INDESIT company

MBM1821V

F036368

51820b0 Exploded views

N1030093fig1

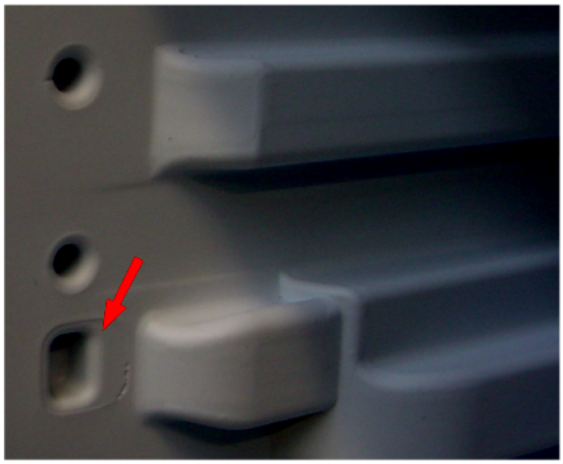
n1030093: New fixing of evaporator on static fridge-freezers (05 range) 60 cm,Melano

From August 05 (serial no. 50802.0001) the freezer evaporator is secured to the cabinet by a plastic profile.
The cabinet walls have been modified to create locations to house the profile, which is installed on the front of each evaporator plate (see photo N1030093fig1- fig2 - fig3)
The profile cannot be fitted on premodification appliances, so technical personnel must continue to fit the rh and lh supports on these models (see photo N1030093fig4)

New parts
C00141135 = WHITE PROFILE L=443.5 MM

Parts replaced
C00075596 = EVAPORATOR RH SUPPORT
C00075597 = EVAPORATOR LH SUPPORT

N1030093fig1

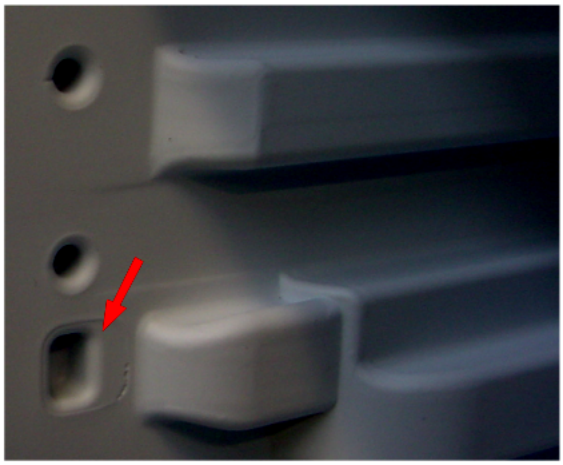
n1030094: New fixing of evaporator on static fridge-freezers (05 range) 60 cm, Lodowek

From August 05 (serial no. 50820.0001) the freezer evaporator is secured to the cabinet by a plastic profile.
The cabinet walls have been modified to create locations to house the profile, which is installed on the front of each evaporator

plate (see photo N1030093fig1- fig2 - fig3)
The profile cannot be fitted on premodification appliances, so technical personnel must continue to fit the rh and lh supports on these models (see photo N1030093fig4)

New parts
C00141135 = WHITE PROFILE L=443.5 MM

Parts replaced
C00075596 = EVAPORATOR RH SUPPORT
C00075597 = EVAPORATOR LH SUPPORT
